January 16, 2019

RE: CU2018-0017, CU2018-0018, DR2018-0123, LD2018-0032, LO2018-0004, PD2018-0002, SDM2018-0006 AND TP2018-0008 PRCA + GARAGE PERFECTION SET

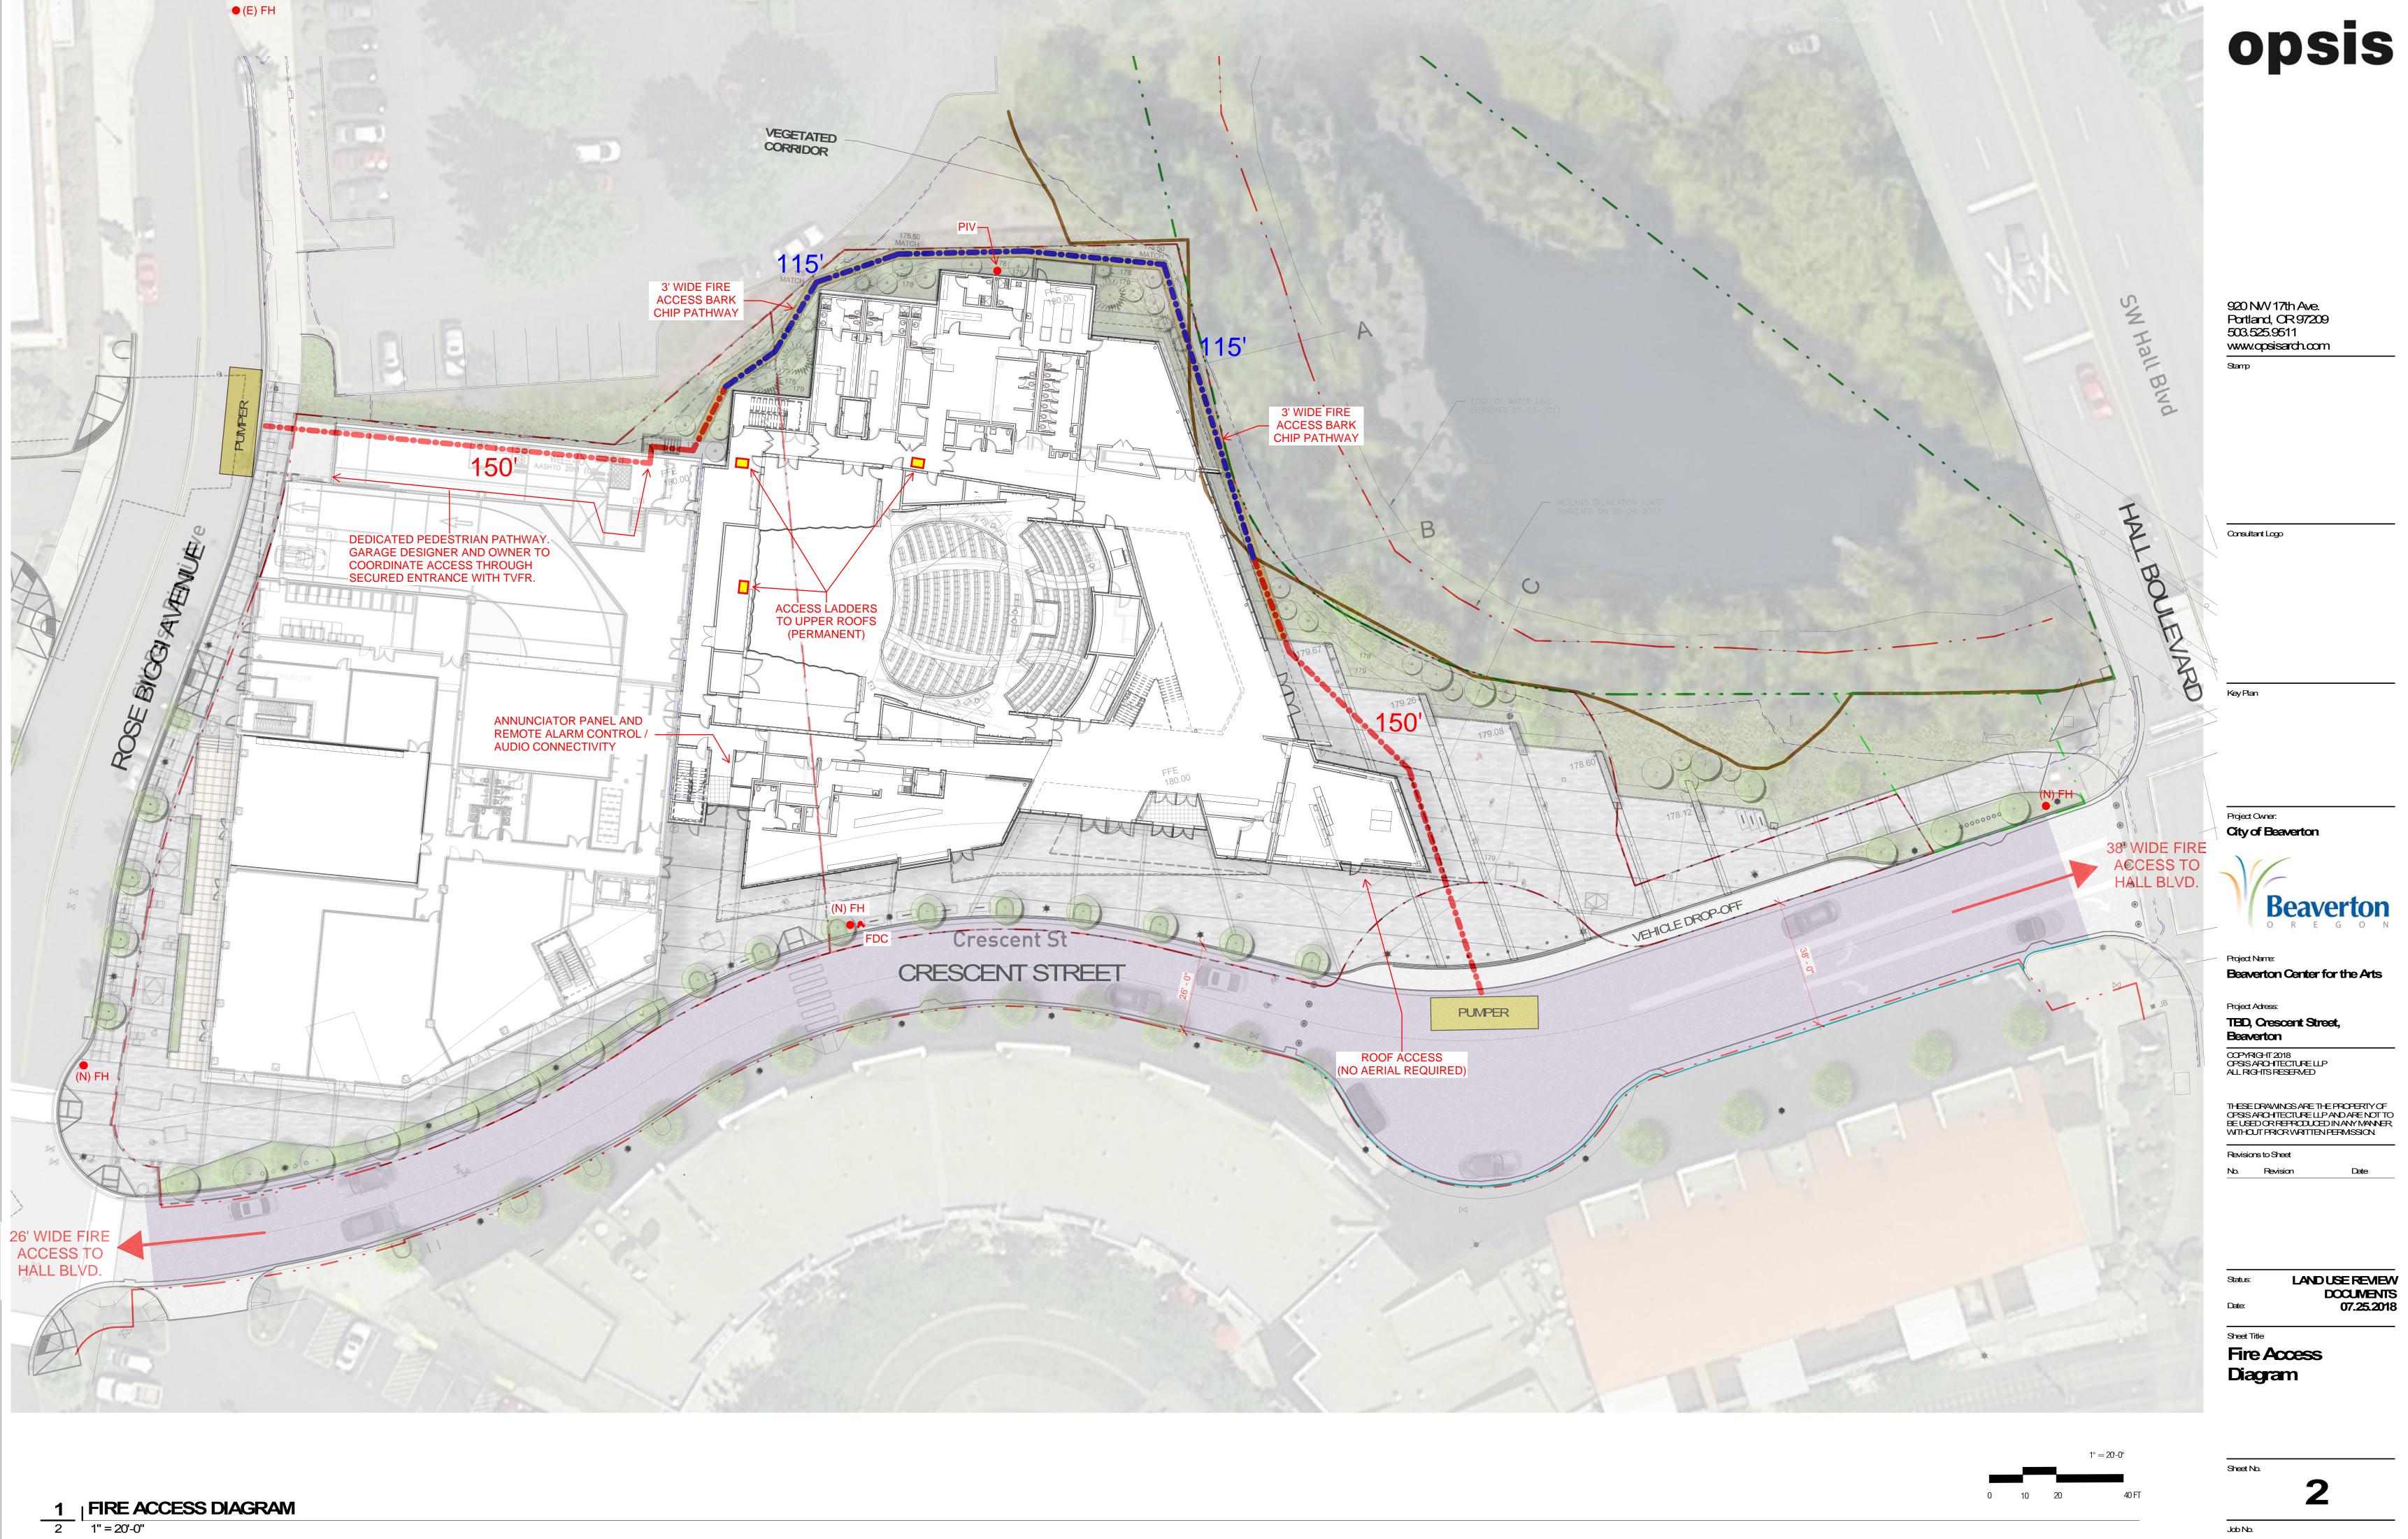
- KNOX BOX: A Knox Box for building access may be required for structures and gates. See Appendix C for further information and detail on required installations. Order via www.tvfr.com or contact TVF&R for assistance and instructions regarding installation and placement. (OFC 506.1) Knox Boxes will be required for these buildings.
- EMERGENCY RESPONDER RADIO COVERAGE: In new buildings where the design reduces the level of radio coverage for
 public safety communications systems below minimum performance levels, a distributed antenna system, signal booster, or other
 method approved by TVF&R and Washington County Consolidated Communications Agency shall be provided. (OFC 510,
 Appendix F, and OSSC 915) This applies to the parking garage portion only.

Emergency responder radio system testing and/or system installation is required for this building. Please contact me (using my contact info below) for further information including an alternate means of compliance that is available. If the alternate method is preferred, it must be requested from TVF&R prior to issuance of building permit.

Testing shall take place after the installation of all roofing systems; exterior walls, glazing and siding/cladding; and all permanent interior walls, partitions, ceilings, and glazing.
